Subject: Duke Energy Corporation
Oconee Nuclear Station - Units 1, 2, and 3
Docket Nos. 50-269, 50-270, and 50-287

Revisions to Topical Report DPC-NE-3003 In Support of
Steam Generator Replacement
Response to NRC Staff Request for Additional
Information

Duke Power Response To Request For Additional Information

DPC-NE-3003 Revision 1 “Mass and Energy Release and Containment Response Methodology”

GOTHIC 7.0 - FATHOMS COMPARISON
ROTSK STEAM LINE BREAK
(1.4 ft² Break)

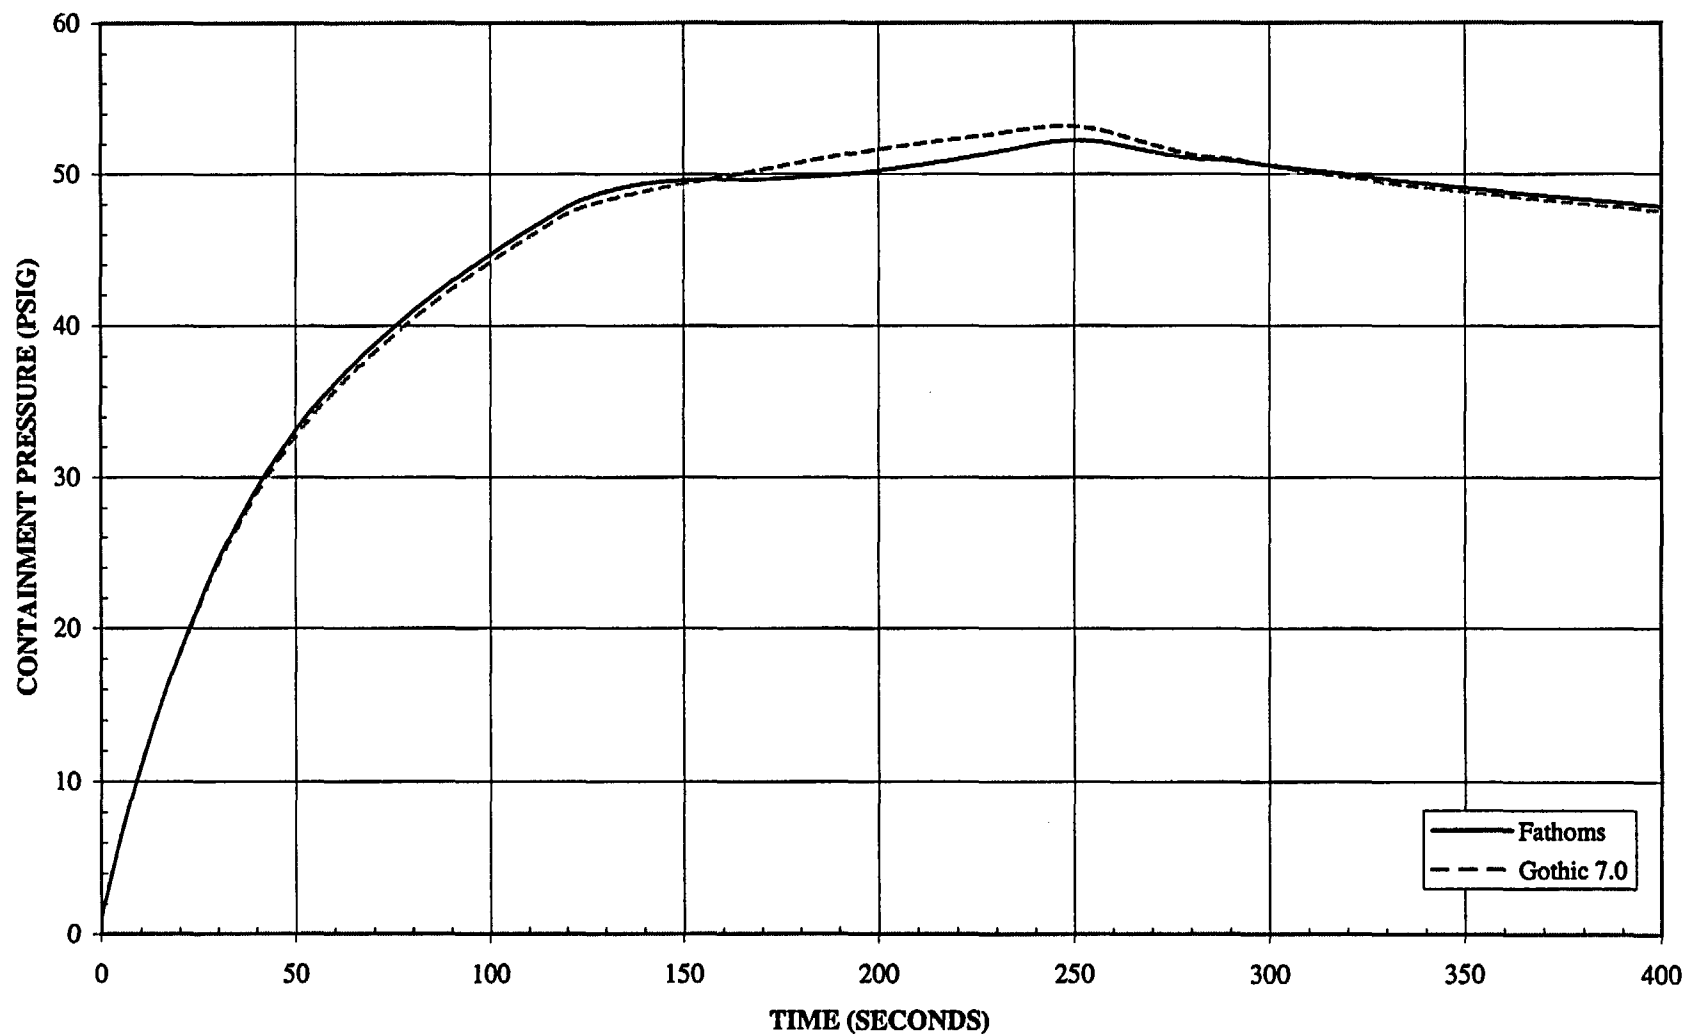
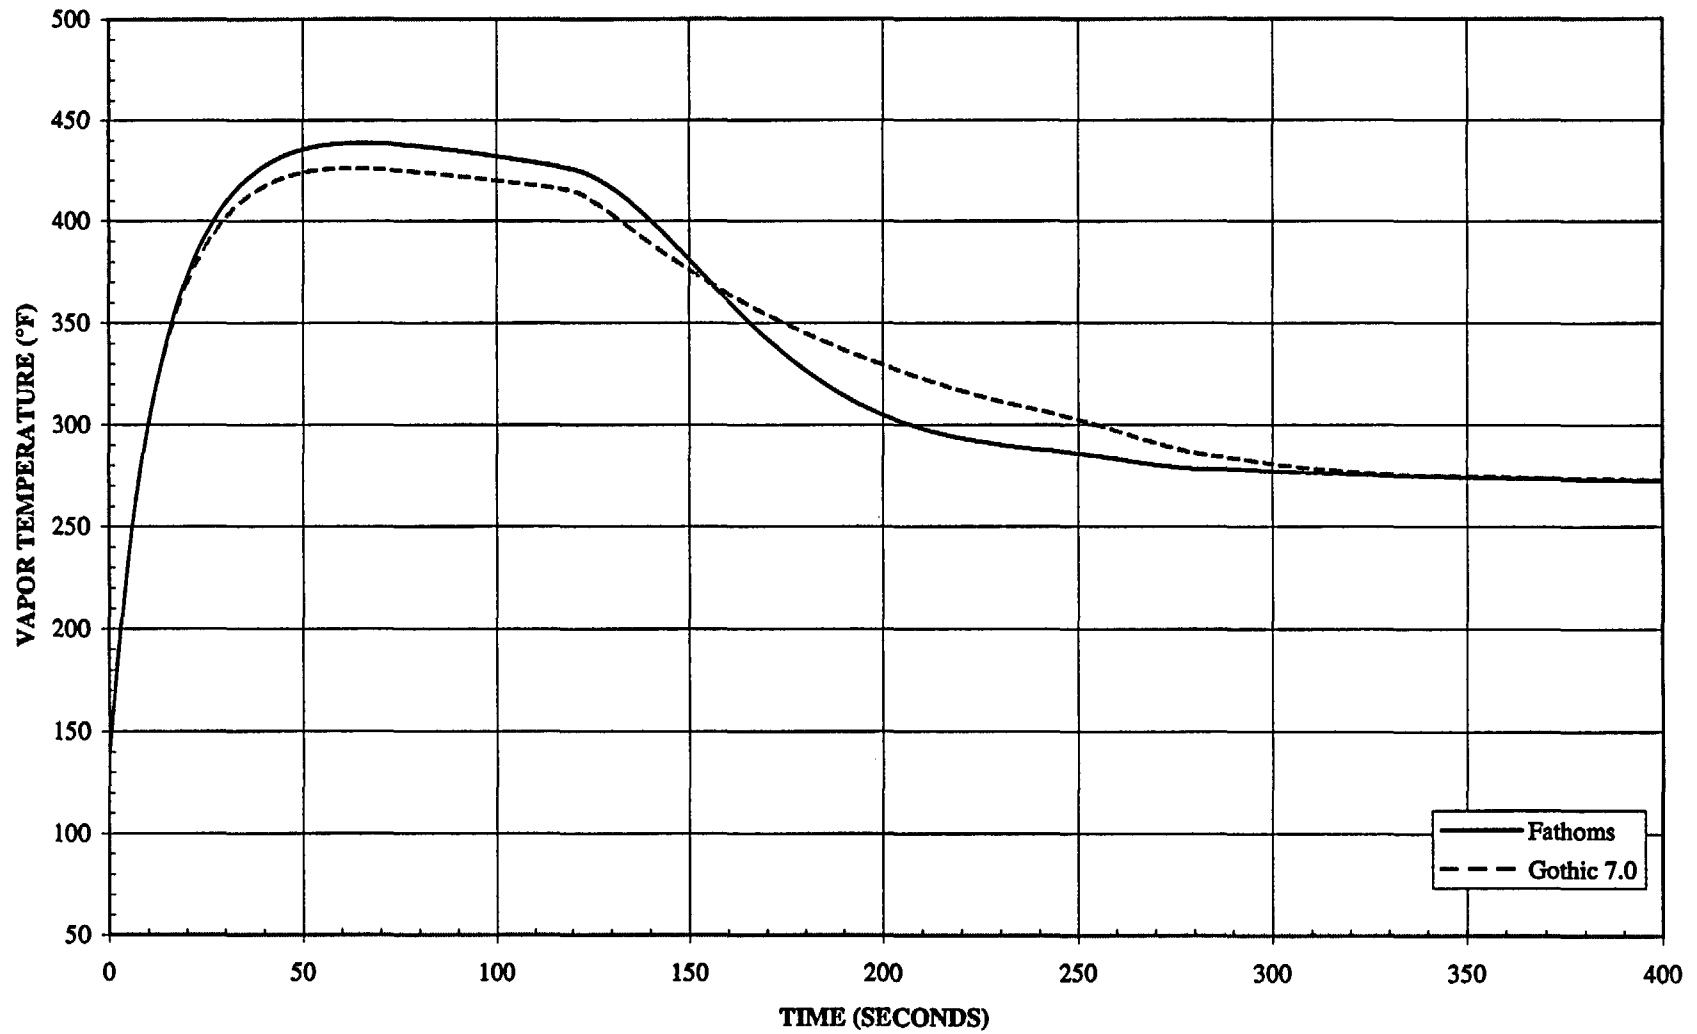
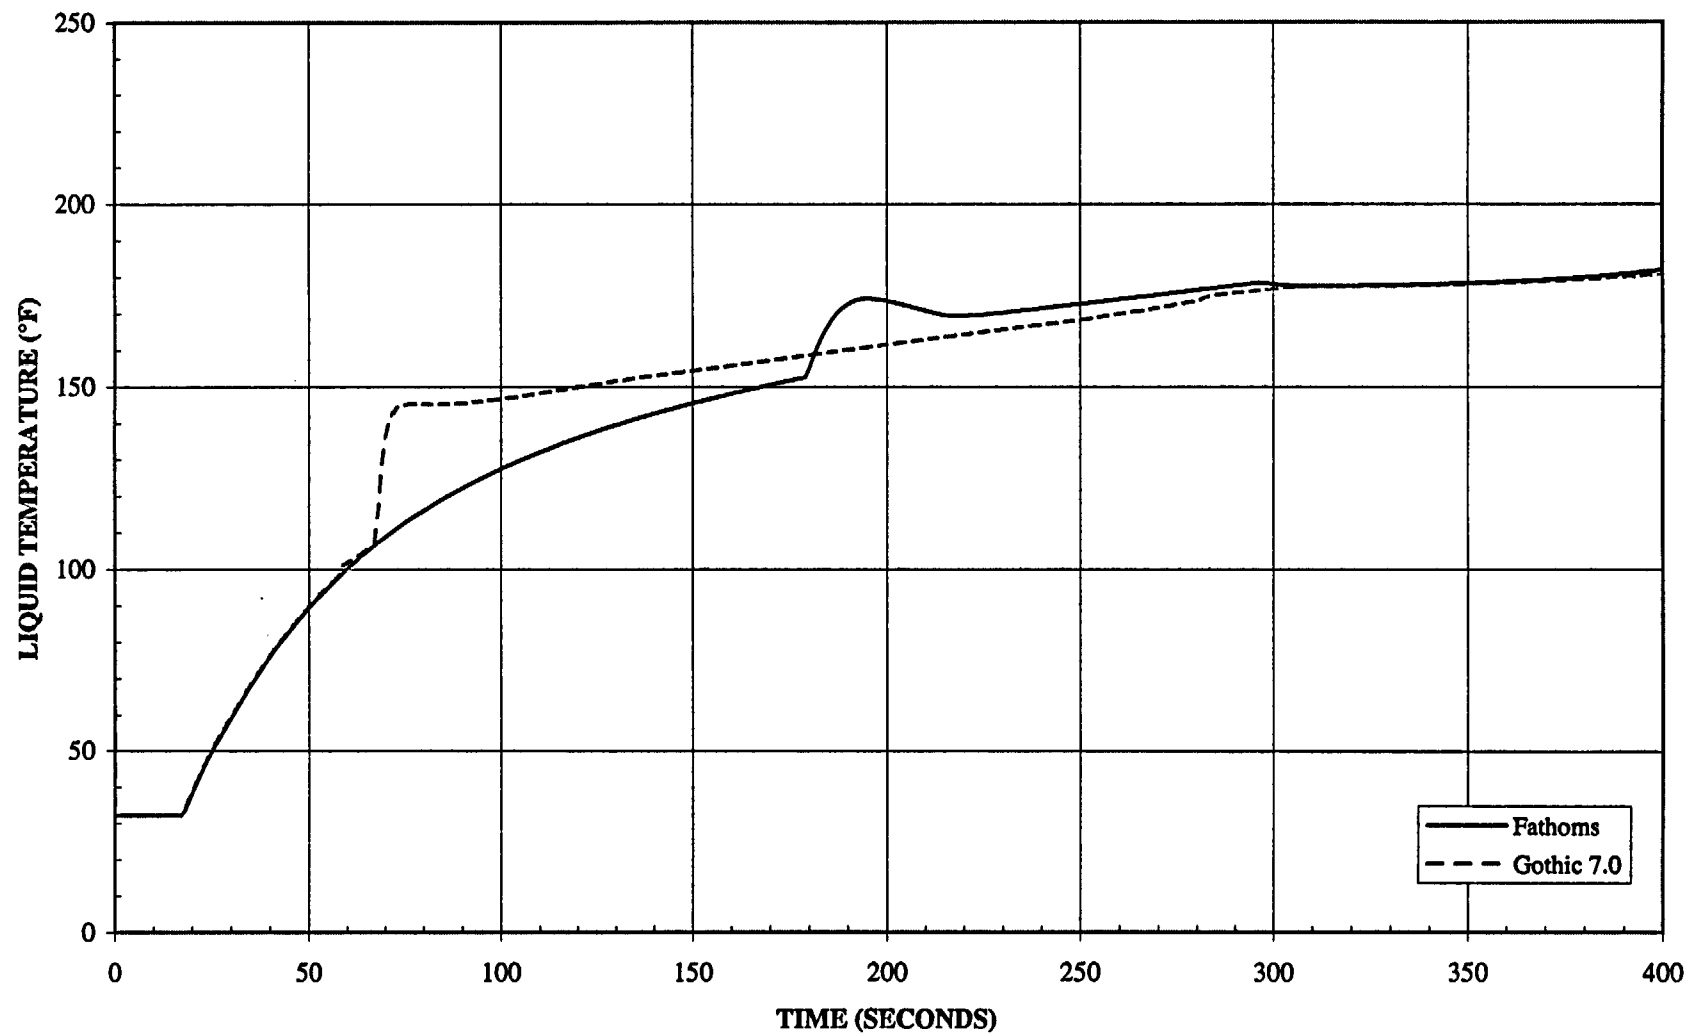
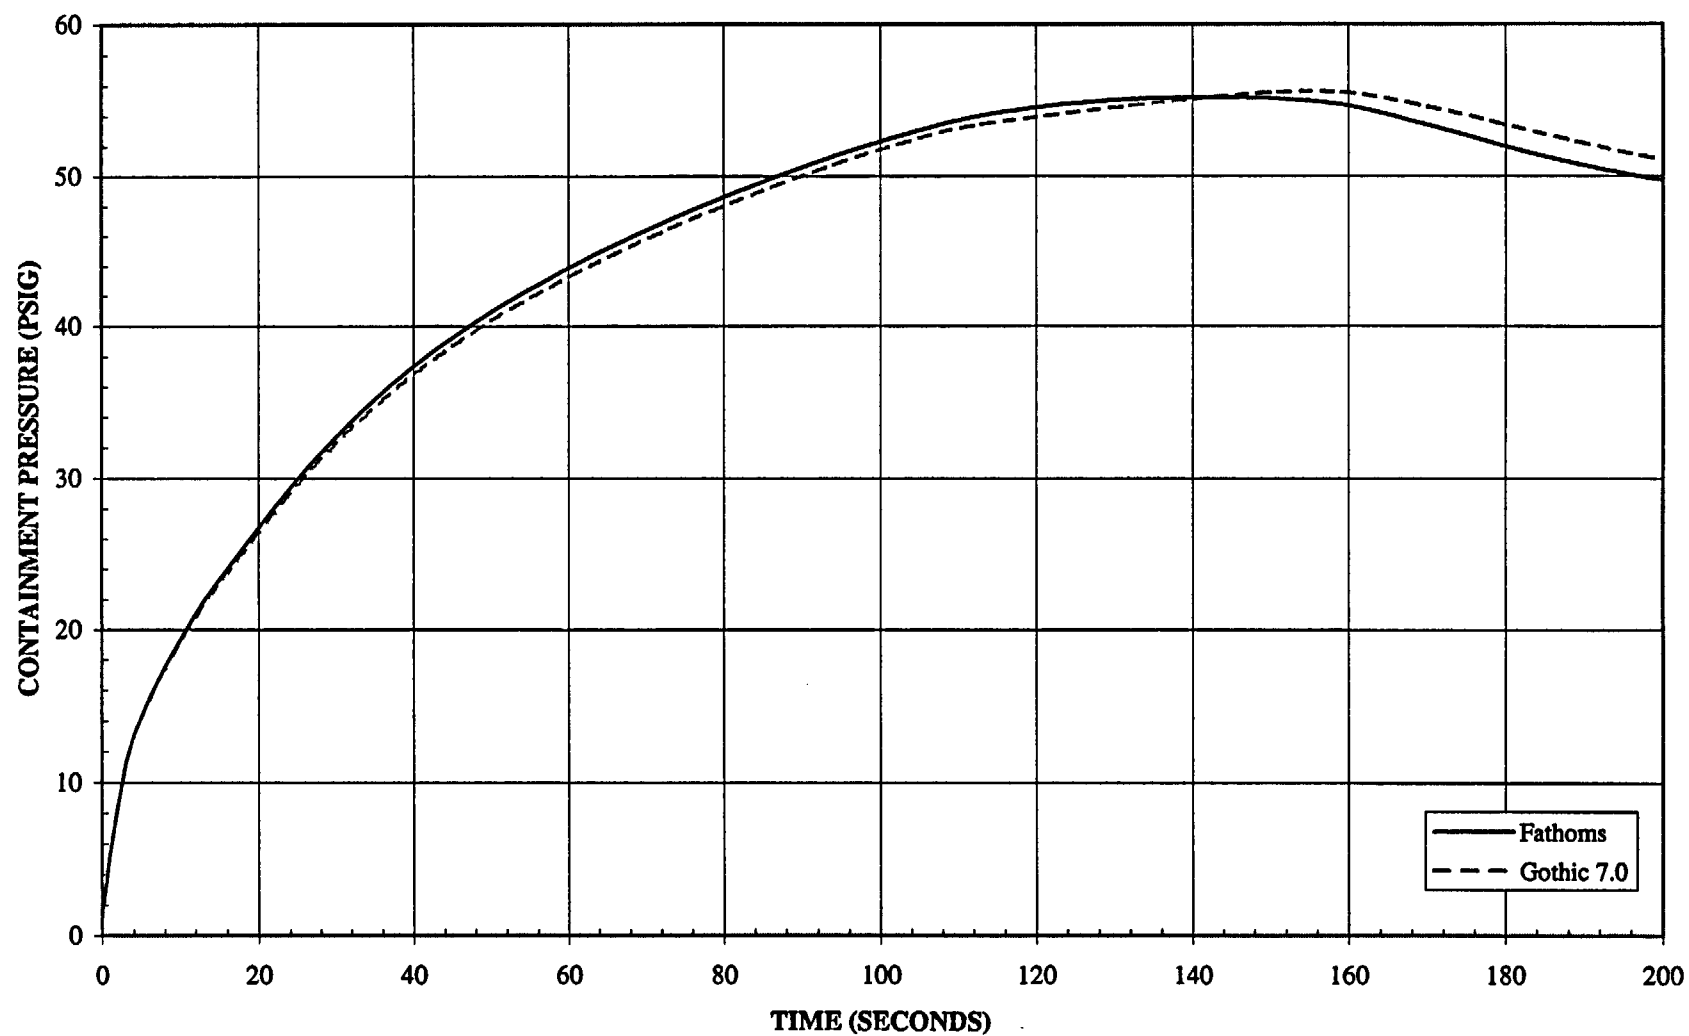
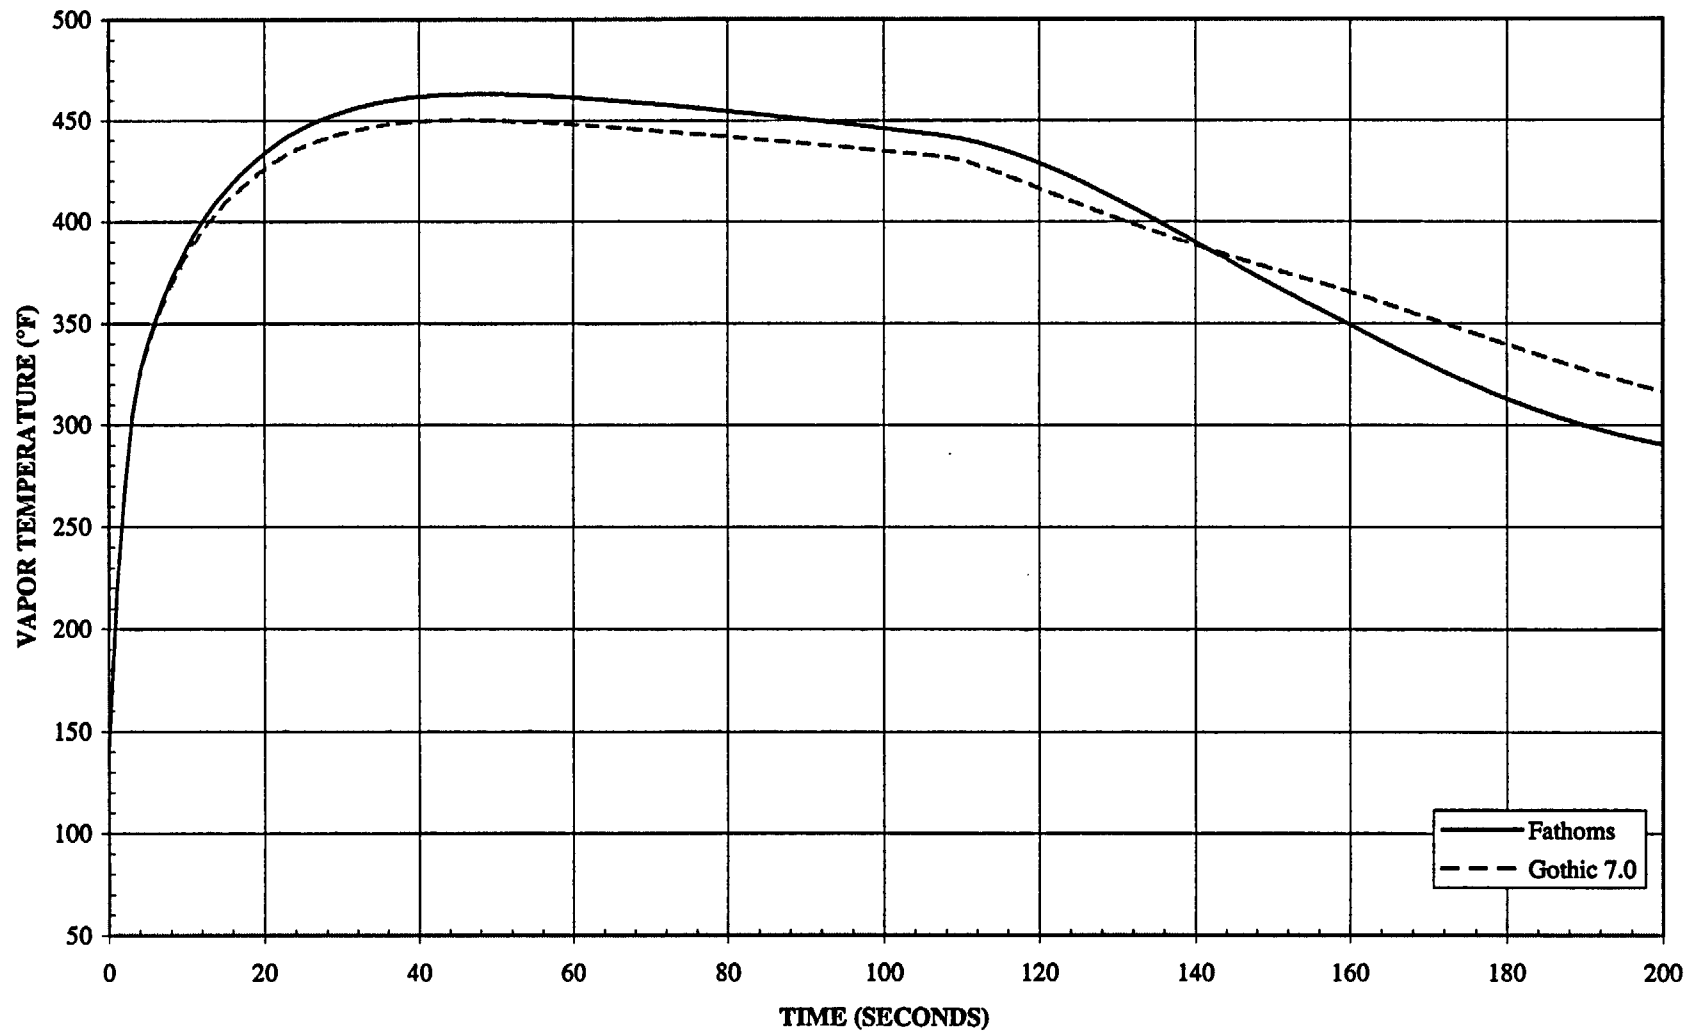
14. Show that GOTHIC and FATHOMS calculations result in the same pressures, temperatures, sump temperatures, etc. for the design basis LOCA and main steam line break events. If they do not, explain differences in terms of the differences in models between the two codes. (See Question 1.)

Response: Refer to the response to Question #3 for LOCA. The results of the 6 code comparison analyses for the main steam line break are given in Table 14-1 and the figures that follow. The containment response following a main steam line break event for the ROTSG was performed to compare the results from FATHOMS 2.4 and GOTHIC 7.0. In general, the pressure and vapor temperature responses are very similar. GOTHIC 7.0 predictions for peak pressures are slightly lower on the smaller break sizes (~0.3 psi) and slightly higher for larger break sizes (~0.95 psi). The peak vapor temperature responses predicted by GOTHIC 7.0 overall are slightly lower (~12°F). For larger break sizes, the higher pressure predicted by GOTHIC 7.0 may be attributed to additional steam generation from the improved interface heat and mass transfer models and from the drops that are generated due to dripping. The slightly lower pressure for smaller break sizes may be attributed to additional droplets in the atmosphere. The slightly lower vapor temperature and liquid temperature in GOTHIC 7.0 for all break sizes may be attributed to additional droplets in the atmosphere also. This effectively increases the heat capacity of the atmosphere and reduces the temperature rise for a given energy addition. As discussed in the responses to Questions #1 and #3, more liquid is predicted to remain in droplet form in GOTHIC 7.0 which results in less liquid mass in the sump. In addition, the lower sump temperature predicted by GOTHIC 7.0 may be attributed to the addition of the second energy equation for the drops and the improved heat and mass transfer models in GOTHIC 7.0.
